**STAFF RECOMMENDATION**  
**1814 Beechwood Avenue**  
**August 19, 2020**

**Application:** New Construction—Addition; Demolition—Outbuilding  
**District:** Belmont-Hillsboro Neighborhood Conservation Zoning Overlay  
**Council District:** 18  
**Base Zoning:** RS7.5  
**Map and Parcel Number:** 10416022600  
**Applicant:** Matthew McCrary, Allard-Ward Architects  
**Project Lead:** Sean Alexander, sean.alexander@nashville.gov

<p><b>Description of Project:</b> The applicant proposes to enlarge an historic house with a rear addition that will be wider and taller. A non-contributing outbuilding in the rear yard will be demolished.</p> <p><b>Recommendation Summary:</b> Staff recommends approval of the proposed addition with the condition that staff shall approve the roof color and window and door selections. With that condition, staff finds that the addition meets Section II.B of the <i>Belmont-Hillsboro Neighborhood Conservation Zoning Overlay: Handbook and Design Guidelines</i>.</p>	<p><b>Attachments</b> <b>A:</b> Site Plan <b>B:</b> Floorplans <b>C:</b> Elevations</p>
---	---

Figure 3: Grade and retaining wall in rear yard.

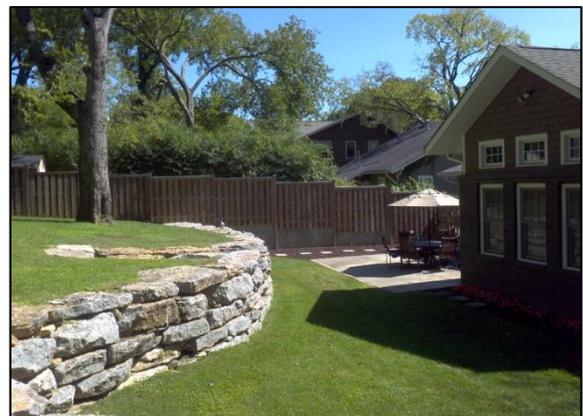
Second, the lot at 1814 Beechwood rises steeply from the back of the house toward the

rear, making it impractical for an addition to extend further toward the rear (Figure 3) without going taller.

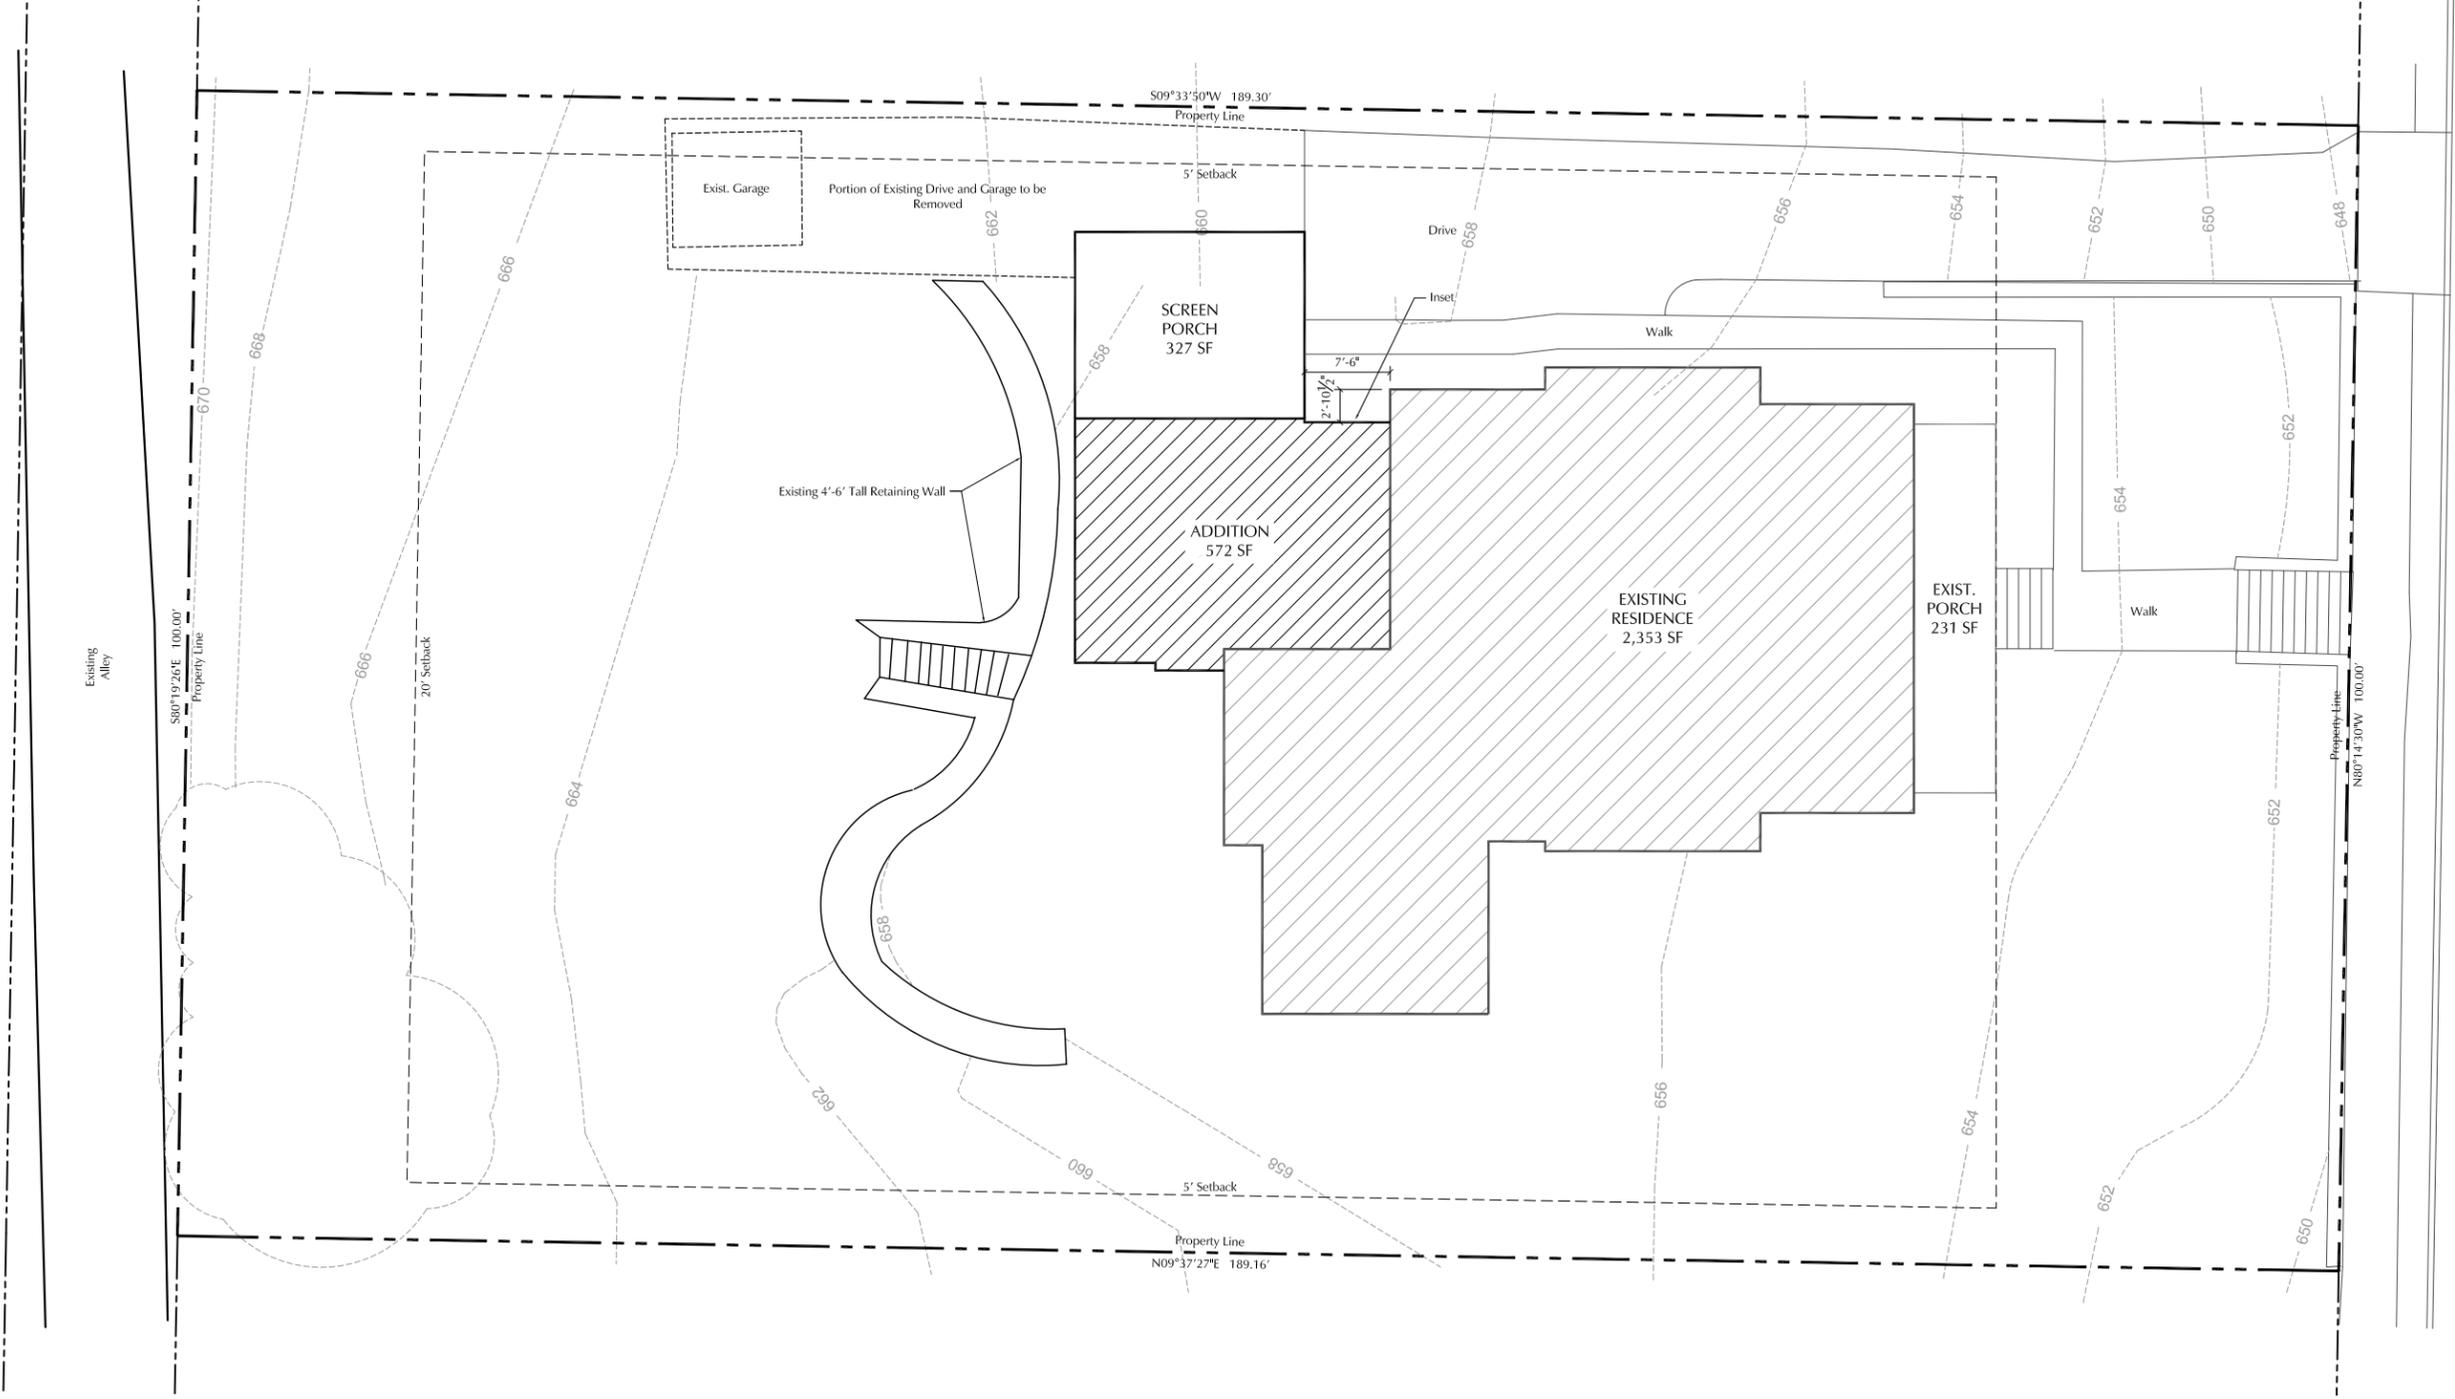
Roof form: The roof of the addition will consist of clipped-gable forms, with a hipped roof on the upperstory dormer. These forms are compatible with the form of the existing roof and will match the 7/12 pitch of the existing roof pitches.

Staff finds that the roof forms of the addition are compatible with the historic house and meet section II.B.1.e of the design guidelines.
